**TOWN OF NEWBURGH
PLANNING BOARD
TECHNICAL REVIEW COMMENTS**

PROJECT: 317 NORTH PLANK ROAD SITE PLAN
PROJECT NO.: 18-23
PROJECT LOCATION: SECTION 35, BLOCK 3, LOT 6 & 7
REVIEW DATE: 14 DECEMBER 2018
MEETING DATE: 20 DECEMBER 2018
PROJECT REPRESENTATIVE: HUDSON LAND DESIGN

PRELIMINARY SITE PLAN
SCALE: 1" = 20'

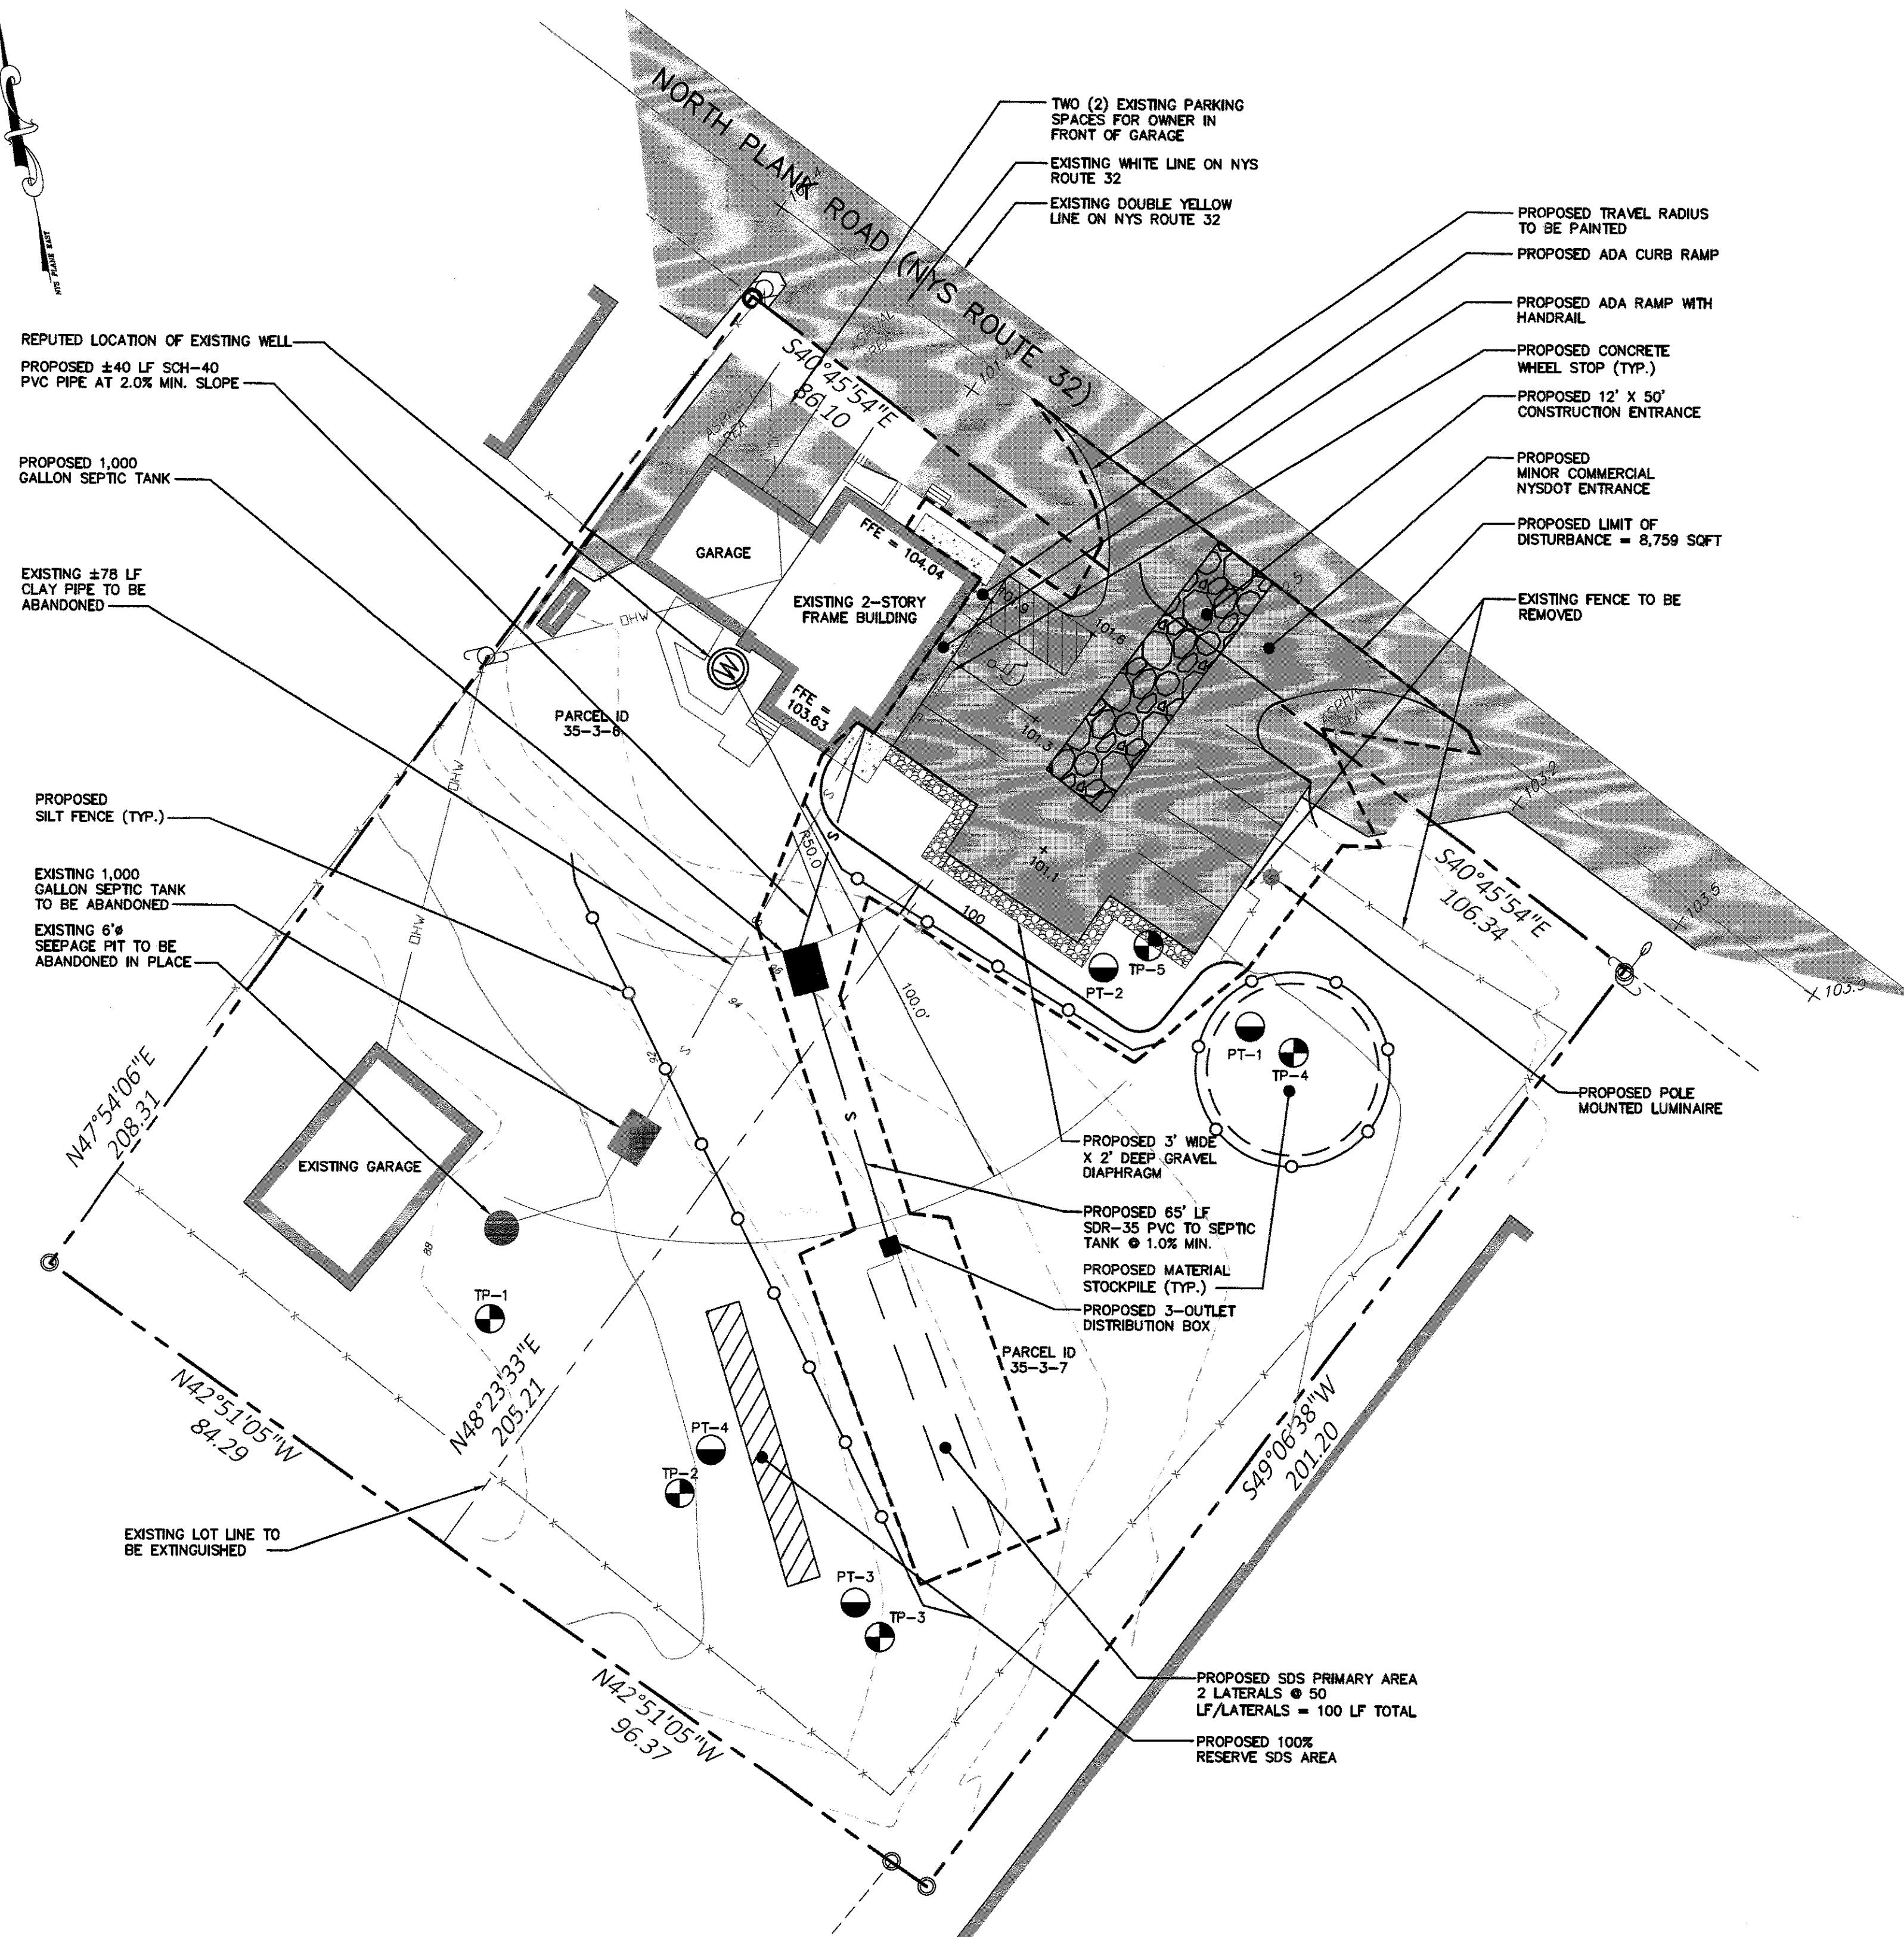
1. The subject project is identified as being served by an on site well. This lot is located in the Town of Newburgh's water district and should be required to connect to the Town's potable water system.

3. The proposed conversion of the existing structure to an office building identifies several bulk requirements which will require ZBA approval:
 - A. Front yard identified as 40 ft. minimum where 10.1 ft. is provided.

- B. Side yard identified as 15 ft. minimum where 10.1 ft. is provided.
4. Driveway access in compliance with NYSDOT requirements must be provided. NYSDOT review and approval of the driveway access and any utilities is required.

7. The Applicant's representative are requested to identify how access to the existing garage will take place from NYS Route 32. NYSDOT will most likely require existing access points to be closed off in favor of one commercial access.
8. NYSDOT minor highway access details should be added to the plans in compliance with DOT standard sheets.
9. Parking lot stripping must be in conformance with Town of Newburgh double stripping standards. Details should be modified.
10. Zoning Bulk compliance should be labeled on the Plan Sheets.
11. Curbing should be clearly identified on the plans. Planning Board's policies to have commercial parking lots defined with curbs.

PRECAST CONCRETE 1,500 GALLON SEPTIC TANK DETAIL
NOT TO SCALE

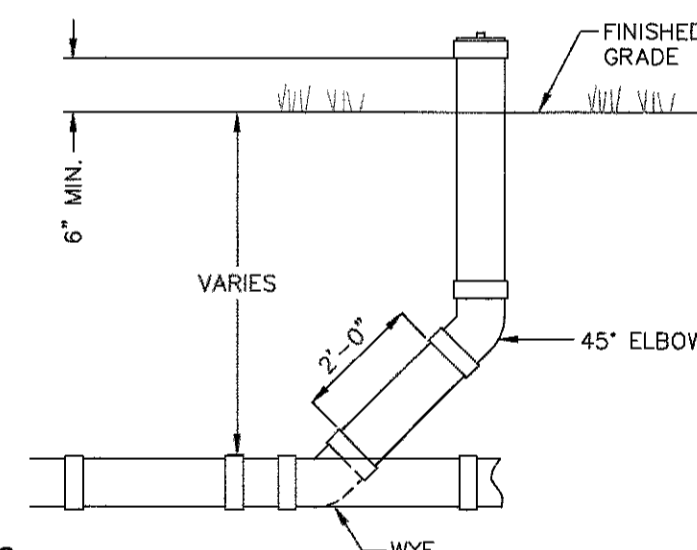
6. The septic design notes identify a 1,000 gallon septic tank while the detail sheet identify a 1,500 gallon septic tank.
